Product hierarchy no.				Part no.	SBU	Product Type	Customer part no.
SBU	PG	PUG	Type				
01	002	003	0000000679	0031.1801 0031.1803 0031.1804	Circuit Protection	FEU (Grip)

2 Type of change

Product Change Notification					PCN FEU (Grip) Change of material		
owner	creation date	release date	released by	change order	rev	page	
zbindeja	23.10.2023	31.10.2023	schulejo	2026686	A	1 of 2	D10-079-351

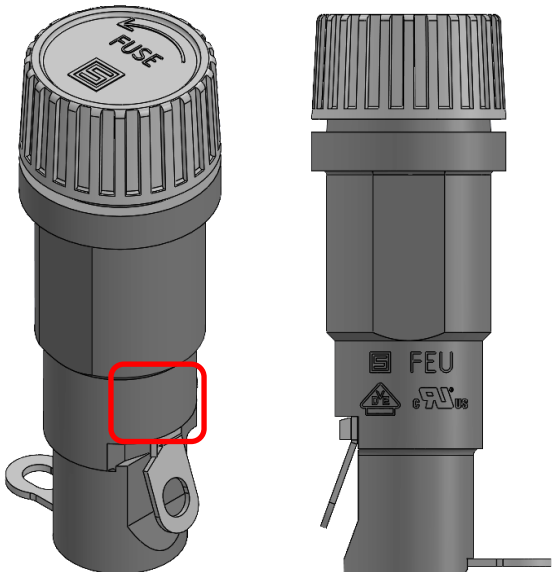
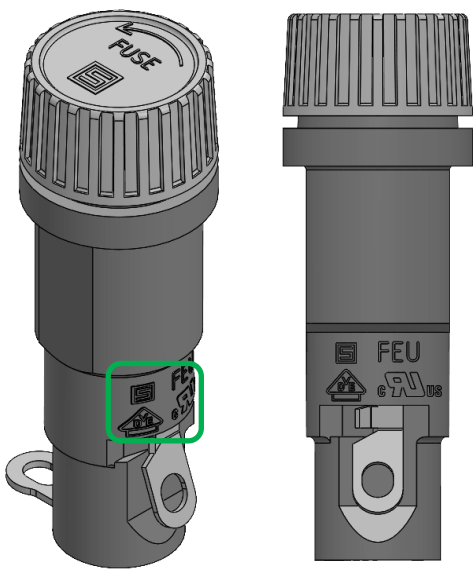
- Change of material

Current material	New material
Thermoset	Thermoplastic
Current product appearance	New product appearance
	 <ul style="list-style-type: none"> Product marking shifted by 90°

- Replace plastic material thermoset with thermoplastic for more reliable moulding process

| <input checked="" type="checkbox"/> Form | No action required. Consider new product appearance at incoming inspection |
